Gardnerville Town Board

AGENDA ACTION SHEET

1. **For Possible Action:** Discussion to approve, approve with modifications, or deny the request from RO Anderson to accept maintenance of a portion of SIP 0057 for the extension of storm drain, including storm drainage manhole and outlet pipe, riparian pad, within Heybourne Road right-of-way of Phase 2E of the Ranch at Gardnerville, recently renamed Heybourne Meadows, Phase 2E; Appearance by Rob Anderson, RO Anderson; with public comment prior to board action.
2. **Recommended Motion:** Conditionally accept the maintenance of a portion of SIP 0057 for extension of Heybourne Road, with accompanying improvements for the town's drainage system, and future stub for a phase 3 cul de sac, outlet pipe and riparian pad into the town's open space within county's road right-of-way of Phase 2E of the Ranch at Gardnerville

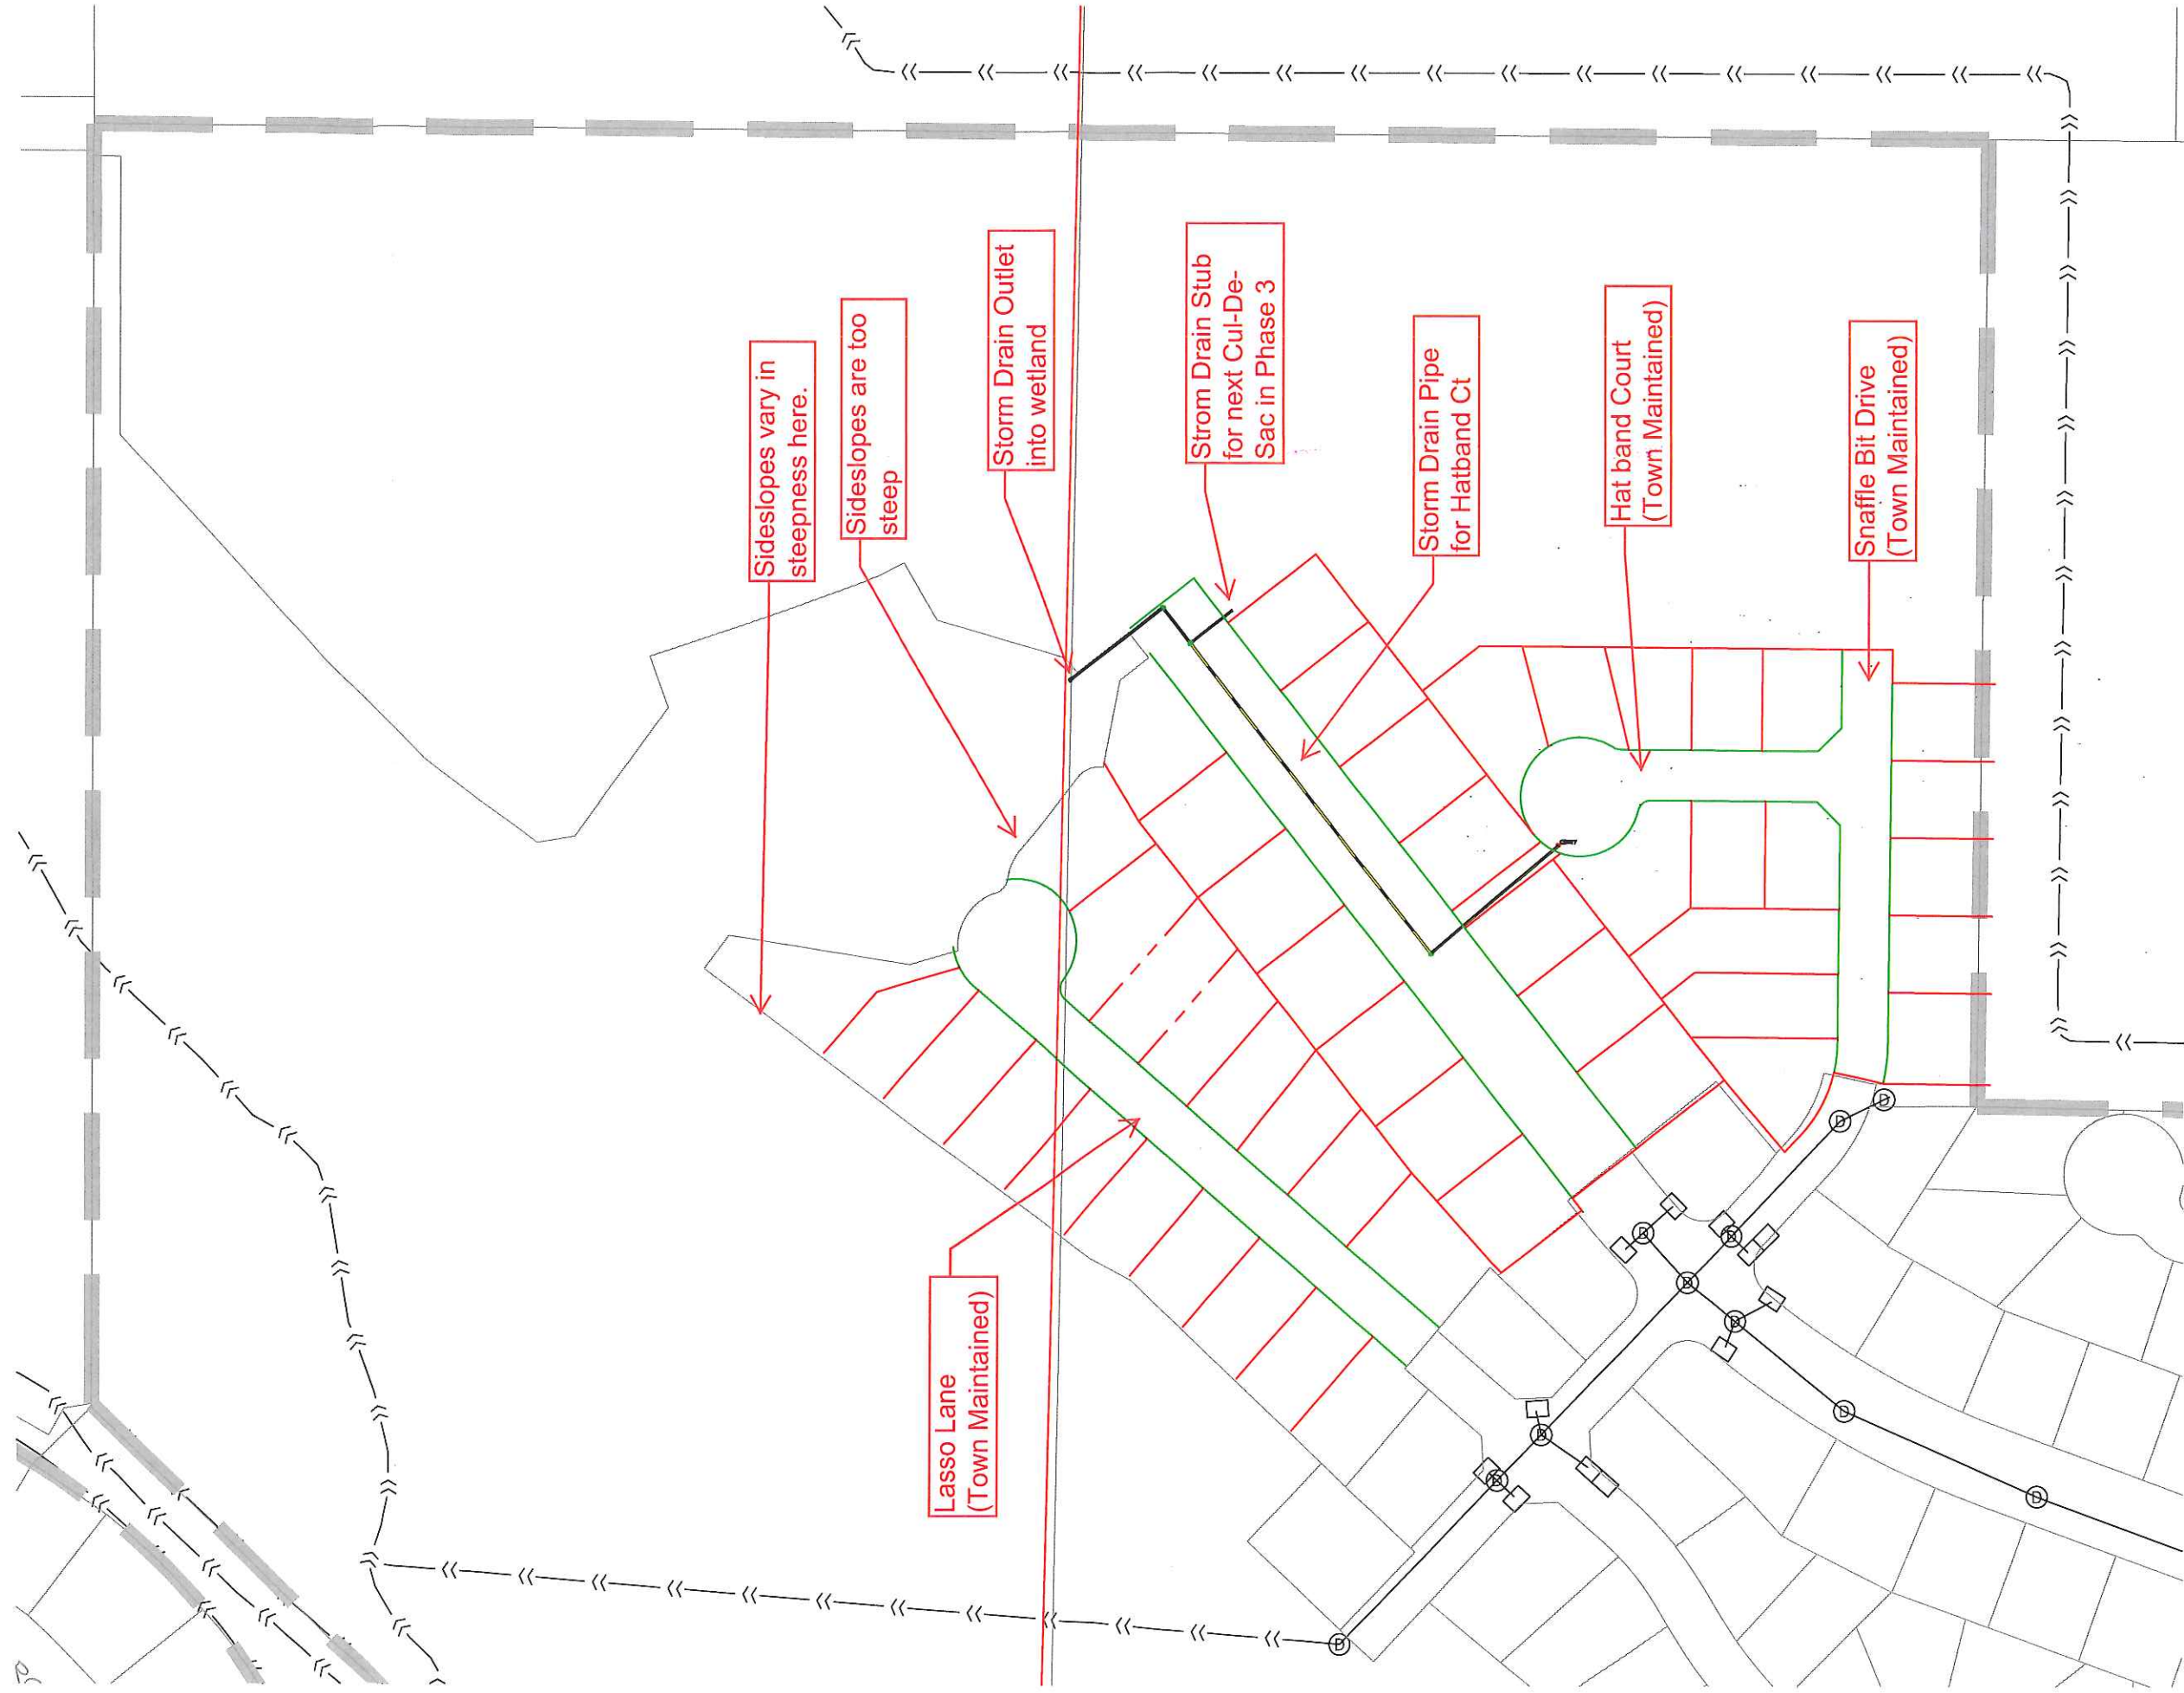
Debris & trash from project needs to be removed.

Good Slope to Match

slope varies on this parcel and gets steeper on north side

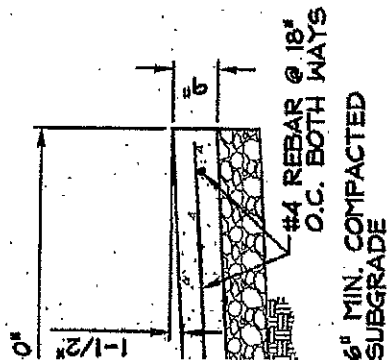
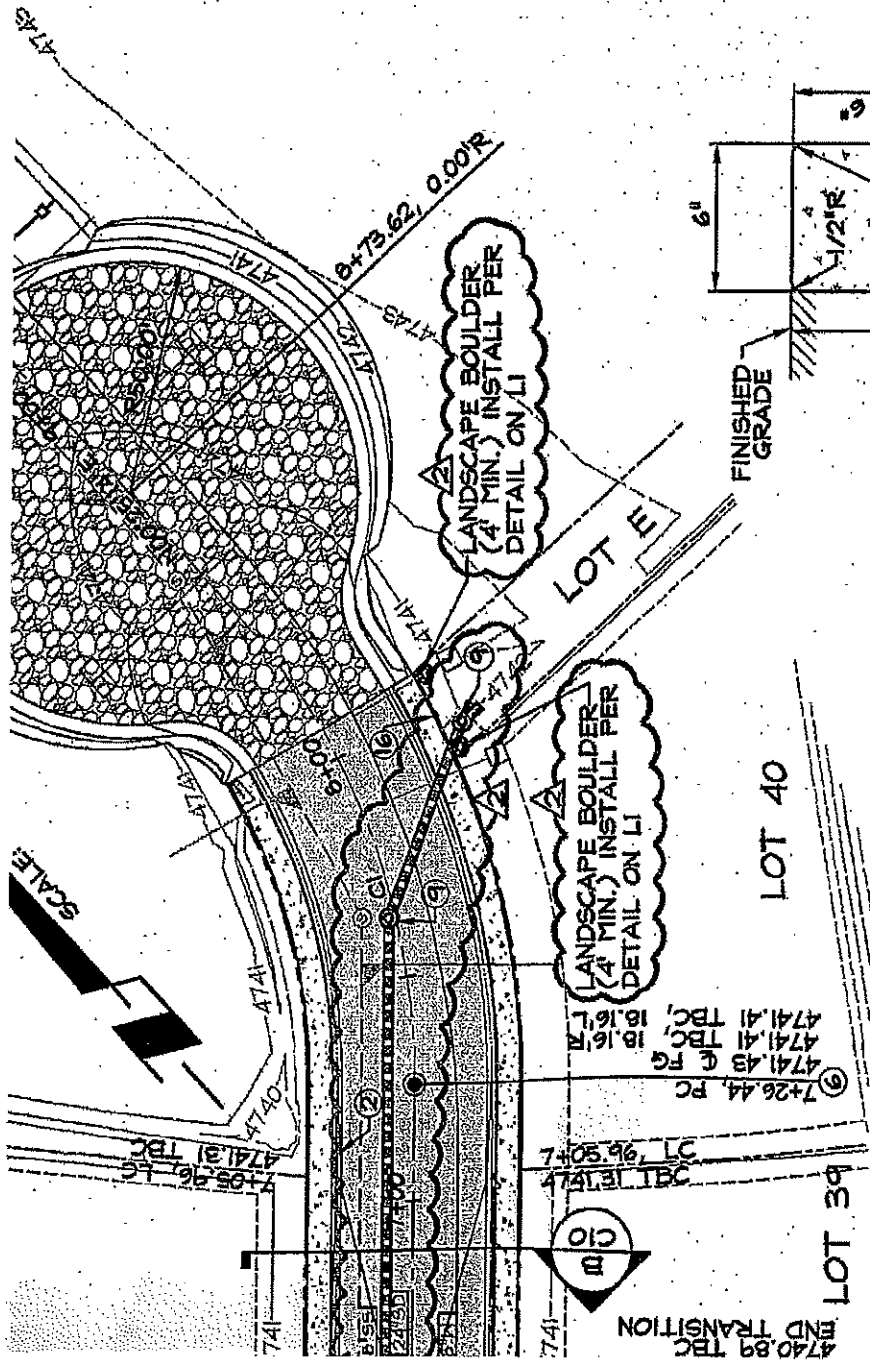
Lot 148 side slope to Heybourne Road are too steep to maintain. We discussed this being pulled out into the open space more. There is a 15'+ slope easements and this seems too steep to me.

Path at Phase 2C home is almost complete and grading, fence and bollards need to be installed.

Path between Hatband Ct and Heybourne will need to be complete once the homes are constructed.
